RE: STATE OF NEVADA PRELIMINARY COMMENTS ON THE SITE CHARACTERIZATION PLAN FOR THE YUCCA MOUNTAIN CANDIDATE HIGH-LEVEL NUCLEAR WASTE REPOSITORY SITE

PRELIMINARY COMMENTS

PROPOSED YUCCA MOUNTAIN  
EXPLORATORY SHAFT FACILITY

MAY, 1989

Figure 1-40. Faults and fractures at Yucca Mountain interpreted from electrical resistivity data. Stippling shows zone of inferred fracturing and faulting along Drill Hole Wash; fault trends appear to change abruptly across this zone. Modified from USGS (1984).

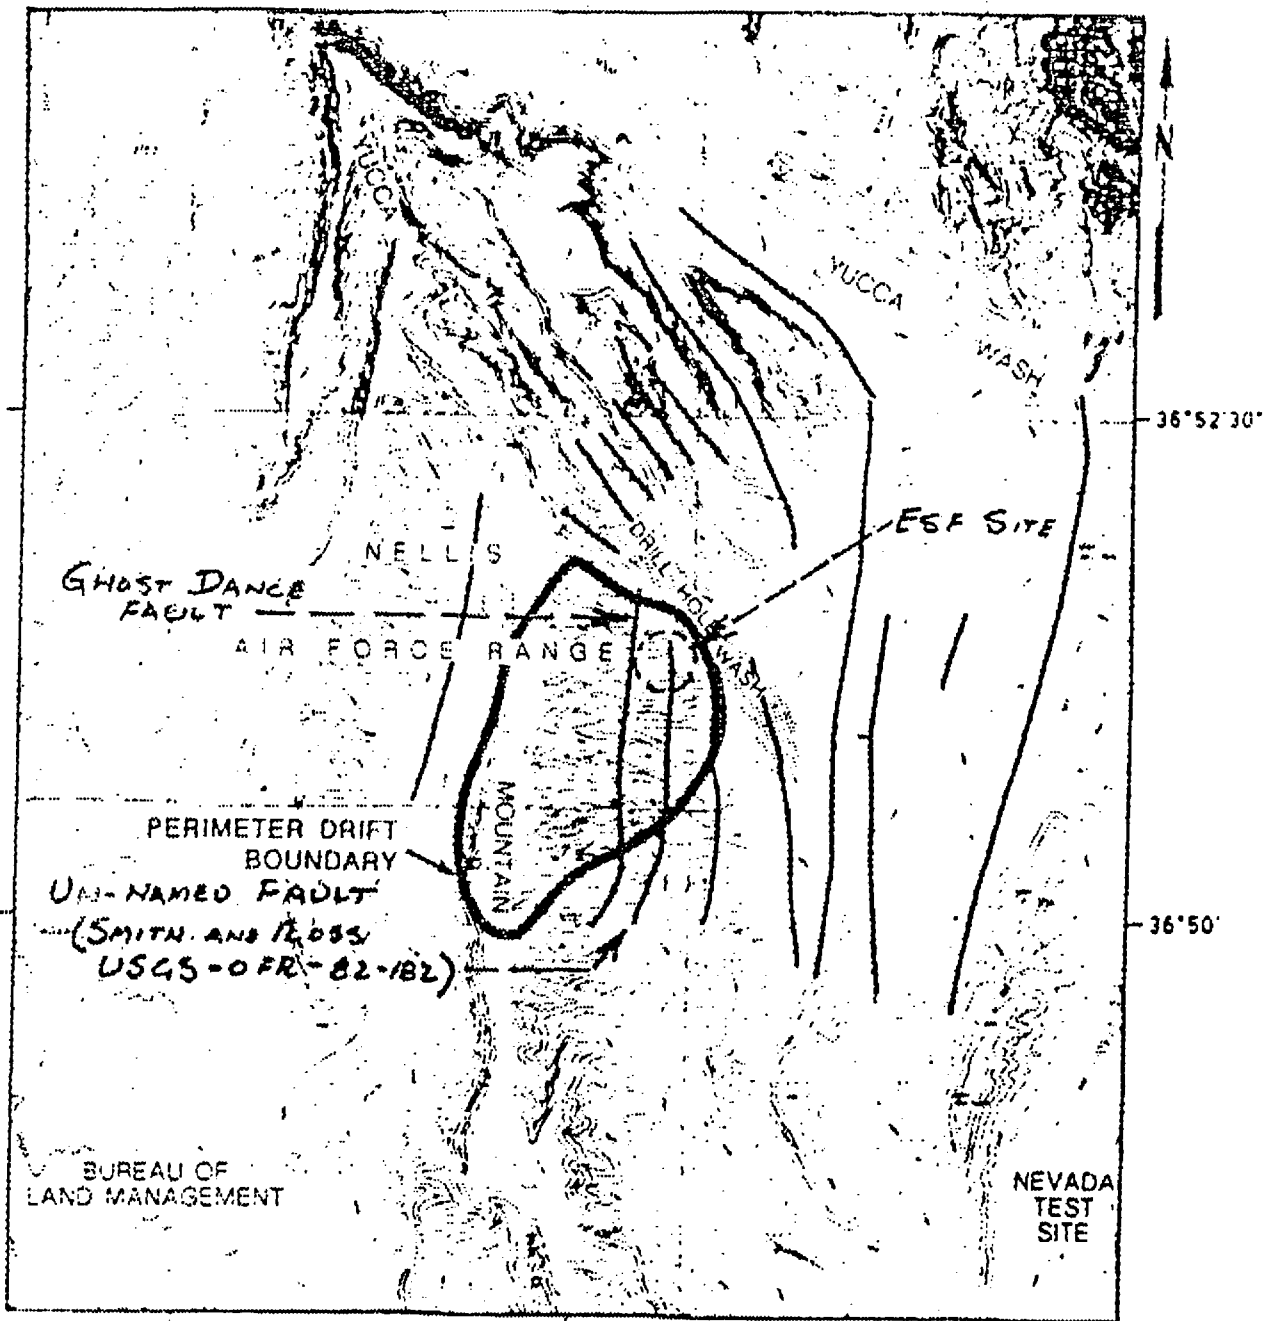
Of particular importance to the ESF is another possible fault lying parallel to and east of the Ghost Dance Fault. This un-named fault identified by resistivity geophysical methods is discussed in USGS OFR 82-182 by Smith and Ross. Plate V of that report maps this fault 400m east of the Ghost Dance. Plotting the ES-1 and ES-2 shaft locations on plate V we find that the proposed fault lies between the proposed shafts. Smith and Ross (page 11) describe the block between the un-named fault and the Ghost Dance Fault as a horst, and suggest (on page 16) that this horst may be a spur of the main fracture zone that underlies Drill Hole Wash.

This fault is also shown on Fig 1-40 on page 1-121 of the SCP and in USGS OFR 84-792 on Fig 3 and discussed on page 50. This fault is not discussed in the SCP, but is described in the USGS report as a fault with at least 5m of displacement.

# YUCCA MOUNTAIN AREA

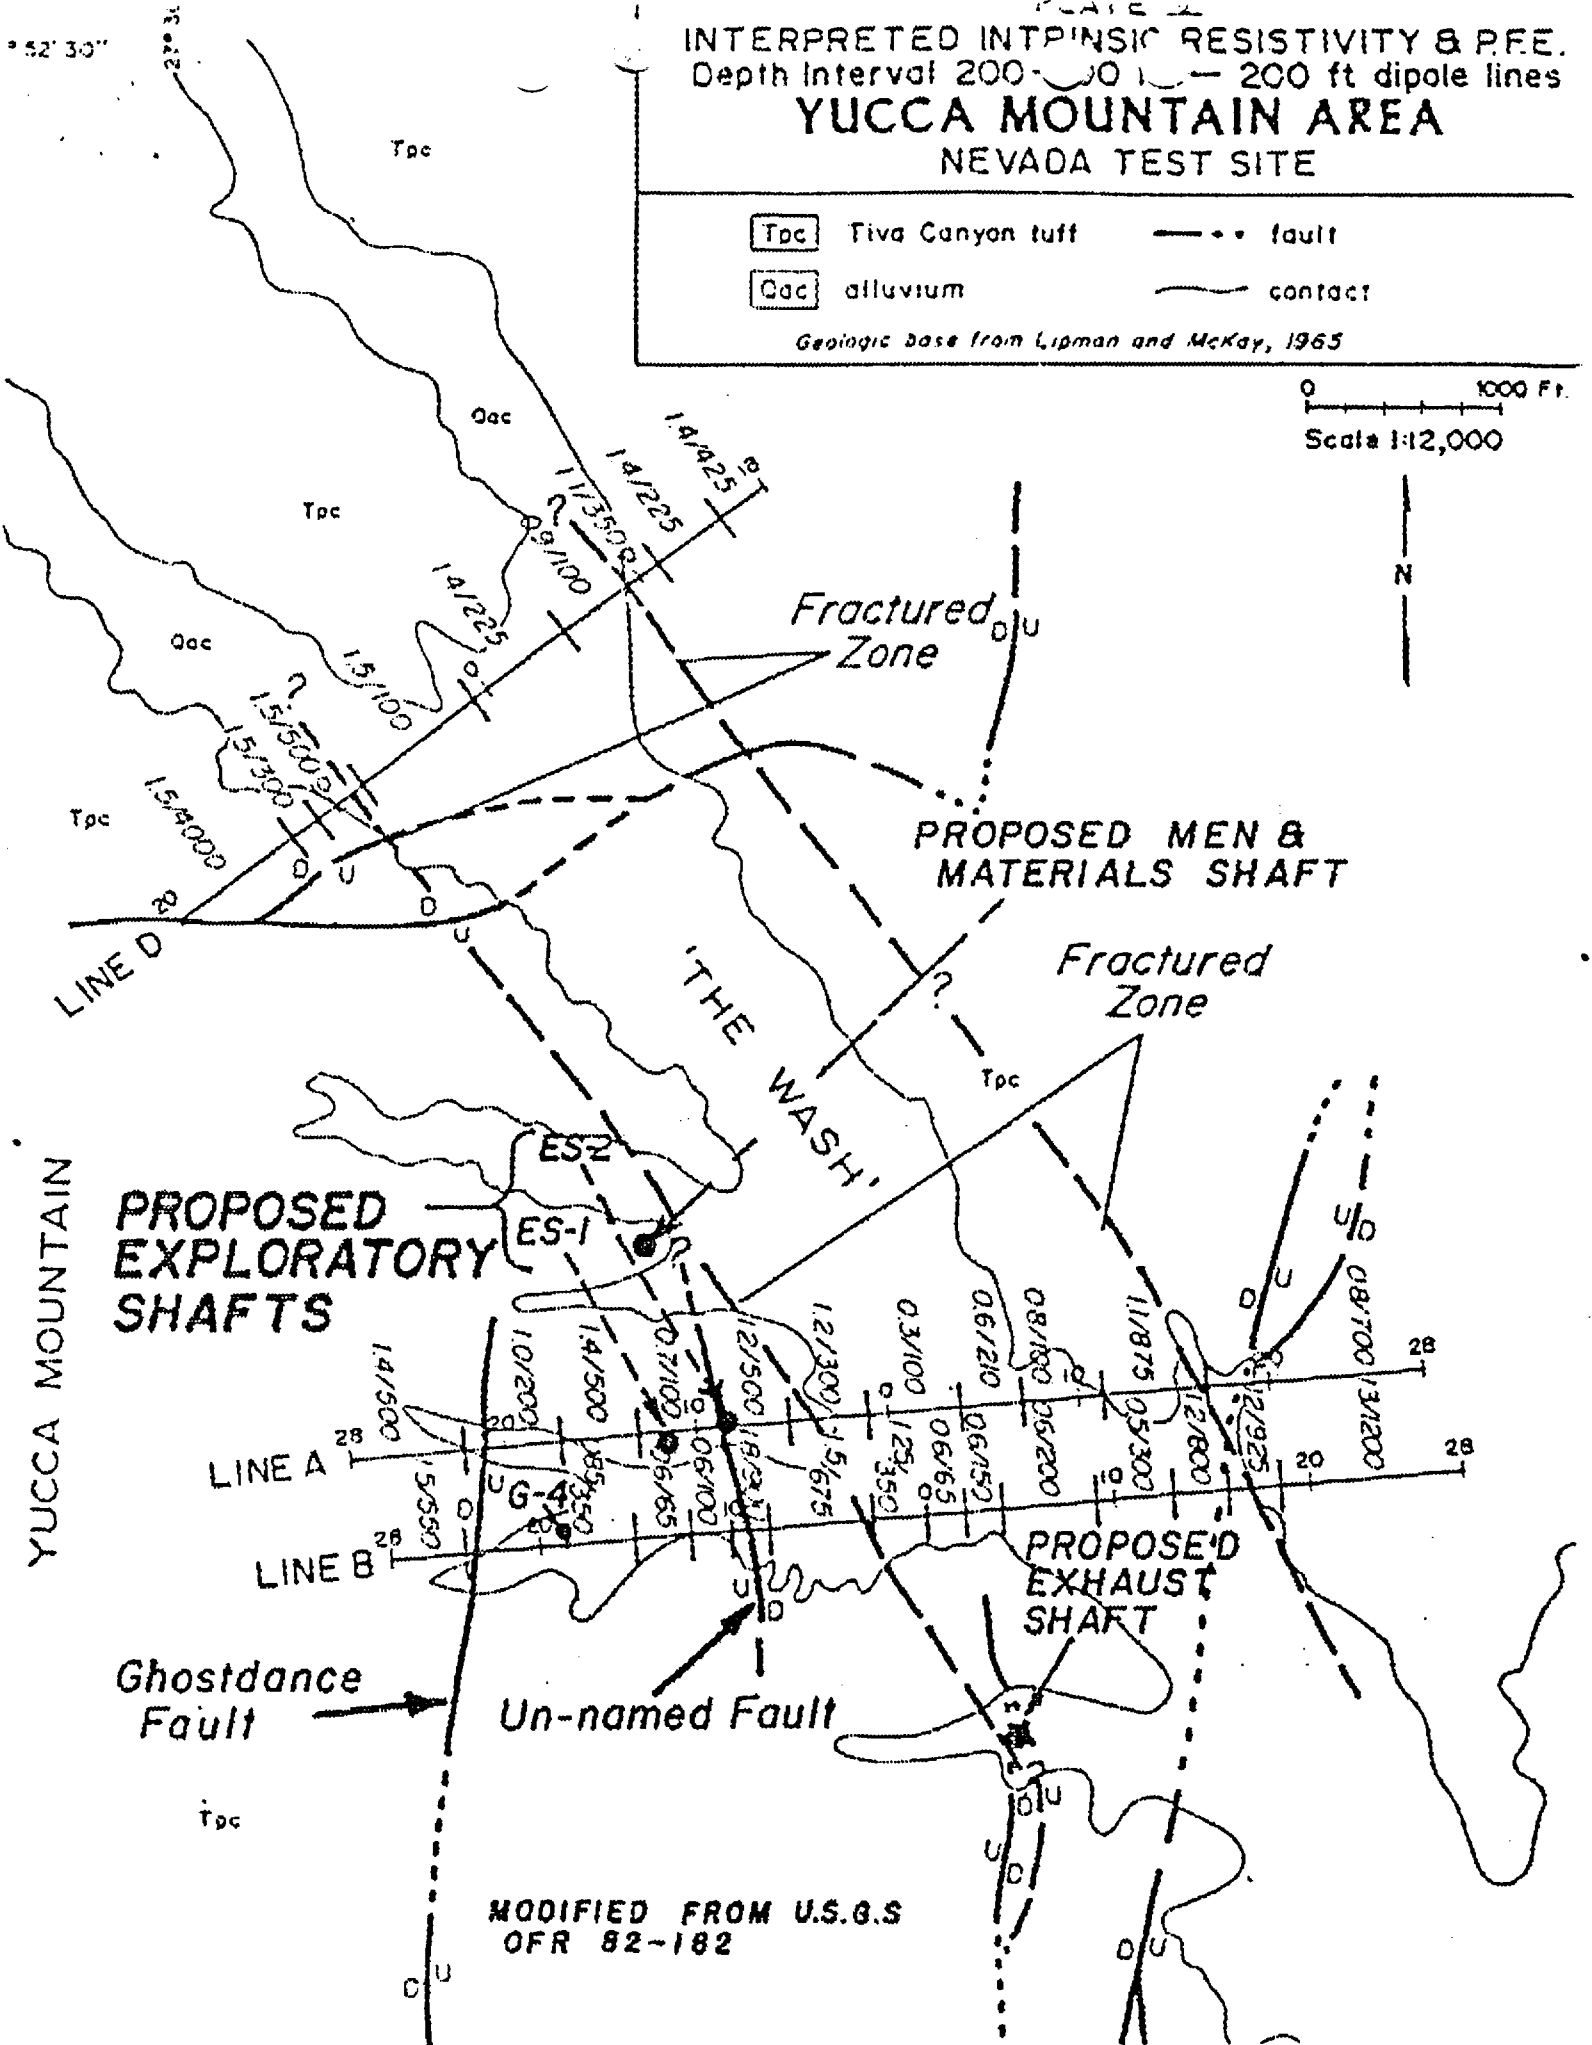
Reviewing the Bertram siting criteria (page 56) regarding setbacks we find two requirements: (1) "ES sites that would have subsurface facilities closer than 100 feet to a potentially adverse structure would be excluded." Either ES-1, ES-2, or the test drifts may well fall within 100 feet of (or intercept) the un-named fault; (2) "The shaft should be located far enough from potentially adverse structures within the block so that there would be a low likelihood that the shaft itself and the drifts would encounter fractures associated with those structures." ". . . A 1000-foot setback distance was judged to be sufficient to place the shaft outside the zones of fracturing associated with the structures." The Smith and Ross report (OFR 82-182) identifying the fault is dated "October, 1979" and therefore was available for the Bertram team in 1982.

**Concern:** Using the two setback requirements for potentially adverse structures developed by Bertram, the Coyote Wash site should have been excluded on both counts. The presence and extent of the fault identified at Coyote Wash must be confirmed and its potential impact on the ESF evaluated before the Coyote Wash ESF site can be considered acceptable.

Concern: Movement in the near-term along the un-named fault between the exploratory shafts could damage or disable the common hoist house and/or hoist foundations; damage or rupture buried service utilities (water, sewer, electrical, compressed air, and communications) lines in the main ESF pad; misalign conveyance guides in the shaft; damage or rupture the shaft liners and utilities in the shafts.

Concern: The un-named fault bisecting Coyote Wash, the main ESF pad and the underground test drifts will provide a pathway for surface water in Coyote Wash to enter the underground facility.
